**Conway Planning Commission  
Staff Report**

**7:00pm • February 21, 2017 • 810 Parkway Avenue**

### CONWAY CITY PLANNING DEPARTMENT REVIEW LEWIS RANCH PHASE II PRELIMINARY PLAT SUBMITTED BY: WILLIAM MAJOR LEWIS TRUST

CONWAY CITY PLANNING DEPARTMENT REVIEW  
 CAMPBELL COVE PUD PRELIMINARY PLAT  
 SUBMITTED BY: HAL CRAFTON

Site Plan

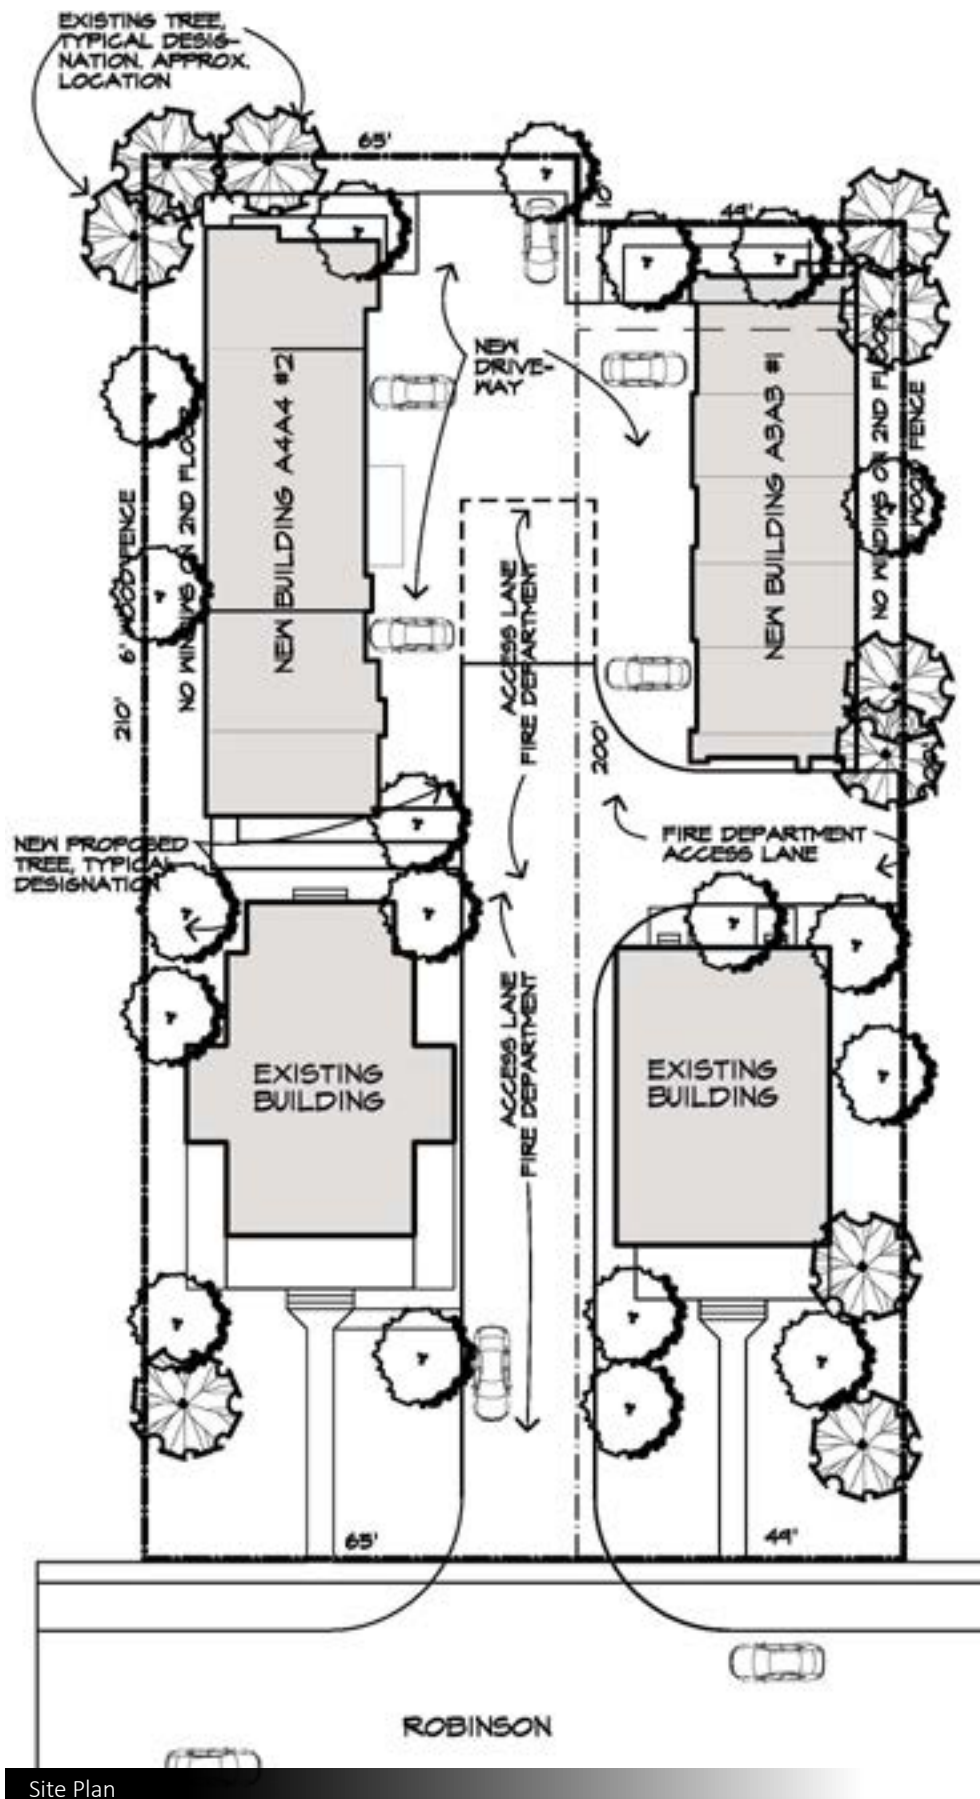
- **Internal Street Network.** A PUD shall include an internal system of streets, parking aisles, and/or cross access drives that can safely and efficiently accommodate vehicular traffic generated by the PUD. *The proposed PUD would use the existing gravel driveway to access a larger gravel driveway/parking area at the rear of the lot between the two new structures.*

- **Sidewalk System.** Unless there are outstanding reasons that warrant otherwise, all internal streets within the PUD shall include pedestrian sidewalks. *There is an existing sidewalk along Robinson Avenue. However, the sidewalk appears to be partially in disrepair. If approved, the sidewalk should be repaired as part of this project. There is no internal street; rather, a gravel driveway. No internal sidewalks are proposed. The gravel driveway would serve as pedestrian access.*

- **Green Space.** Planned Unit Developments less than three acres shall dedicate a minimum of 5 percent to 20 percent of the total project area to pervious surface typically reserved for green space and/or landscaping. *Around 40% permeable green space is shown.*

The proposed PUD would introduce a level of residential density that is not typically found within the Asa P. Robinson Historic District. The District consists mainly of single family and duplex residences. Of 135 residential structures in the district, 4 multi-family structures have a similar level of density; 1618 and 1622 Robinson (3 blocks east), and 915 and 931 Faulkner Street (.4 miles northwest). These structures were originally built as walkup multifamily dwellings and are the sole structure on each lot. They have a density equal to MF-1 (12 units/acre).

In general, Planning Staff is supportive of denser infill developments. However, this proposal is in the heart of a local certified historic district. One of the key roles of this historic district designation is preservation. There is no historic precedent or context for a development of this type and density within the Robinson District. The proposed structures are somewhat similar to “carriage houses” with a living unit above a garage. However, they are very large for carriage houses. There are several examples of small living units above a garage in the Robinson District and the Old Conway area. There is no precedent for multiple living units above multiple garages in Conway’s historic areas. The proposed new structures are 2 story in height. As proposed, the structures will be visible above the one story duplex’s rooftops. The developer has indicated that the proposed structures are very similar to existing garage apartment units at Centerstone Apartments at Dave Ward Drive and Moix Boulevard.

1. The PUD shall allow a maximum of 9 (or less) residential units. (A possible compromise might be (1) additional residential unit per lot behind each existing duplex or (6) units maximum)

2. The PUD shall have a maximum of 8 (or less) garage units. (A possible compromise might be (1) additional 2 car garage per each existing duplex for a maximum of (2) 2 car garages)

3. New structures must be situated to minimize visibility from Robinson Avenue.
4. Any signage must be approved by the Historic District Commission.
5. The PUD shall be generally developed as shown on site plan. Specific structure design, materials, landscaping, and variations from the submitted plan shall be allowed per Historic District Commission review. However, the density and intent of the site plan shall be followed.

6. Platting shall be required.
7. Setbacks, easements, etc shall be defined in the final development plan and PUD documents. Some dimensions, such as setbacks, shall be determined during Historic District Commission review.
